RE: Item 18, 1609 S. Park Street

Re: Legistar #78428, 1609 S. Park St.
Meeting of August 28, 2023, Agenda Item 18

Plan Commission
Meeting of August 28, 2023
Legistar #78428, 1609 S Park

Google Street View, July 2022

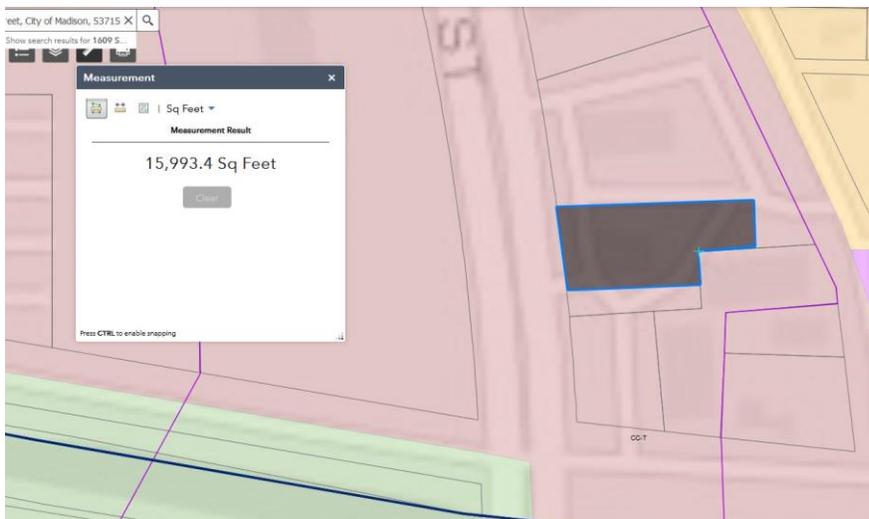
MGO 28.185 defines demolition as "An act or process that removes, pulls down, tears down, razes, deconstructs, or destroys an existing building wall facing a public street..." This section has been applied in the past, see, e.g., Legistar 29724, where an auto dealer remodeled and the front façade was removed and replaced.

- The sunroom-like structure to the left is being demolished.
- The building wall to the right is being demolished. This wall, with its window, is under the main building roof. There is a visible opening at the front and another to the south, making this area into a sort of covered breezeway.

- See pdf page 14, sheet D1.2, "Demo Floor Plan" which refers to "wall" and "screen wall."

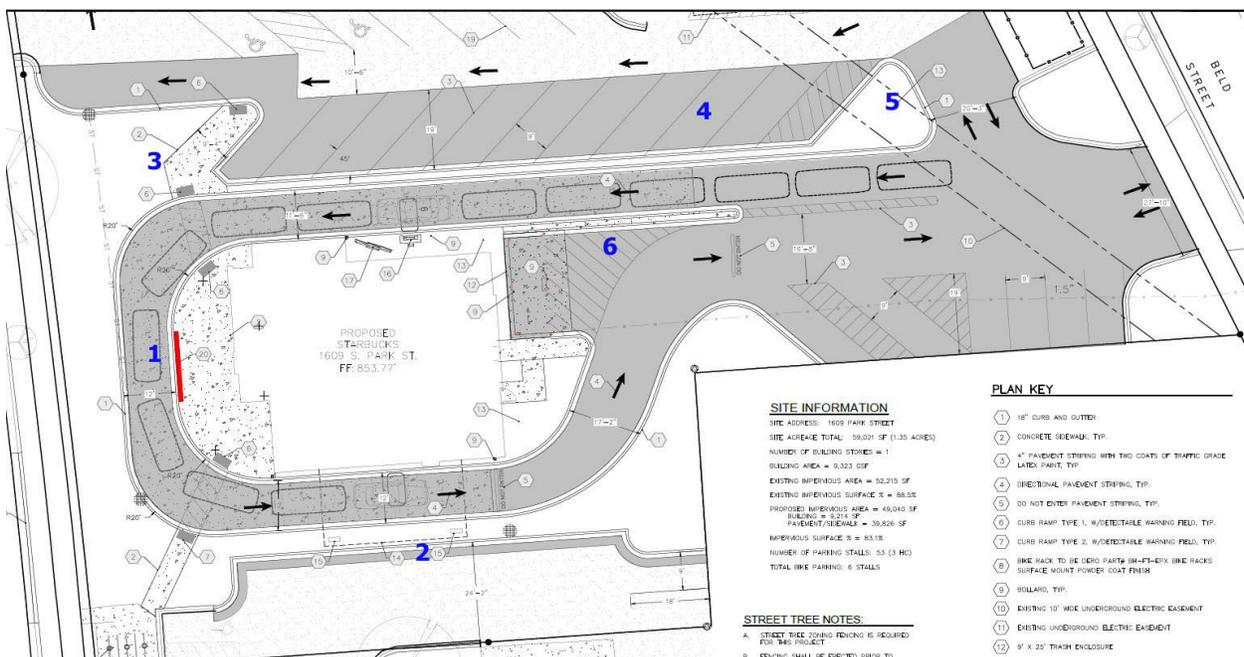
The changes being made to the southern half of the site go beyond these exceptions.

1. The front drive aisle/vehicle access sales and service drive is being flattened and moved closer to the building. The existing drive will overlap with the new drive for only a short stretch – most of the drive is pulled closer, though at the southern end the drive is pushed a bit further from the building.
2. The access through the parking lot to the south is being closed off.
3. The existing drive from the north side of the property is being closed off and replaced with lawn.
4. Three or four new parking spaces are being created.
5. The new grass area will be in an area currently a drive.
6. The lot is being marked with yellow stripes to show it is no longer a drive area.
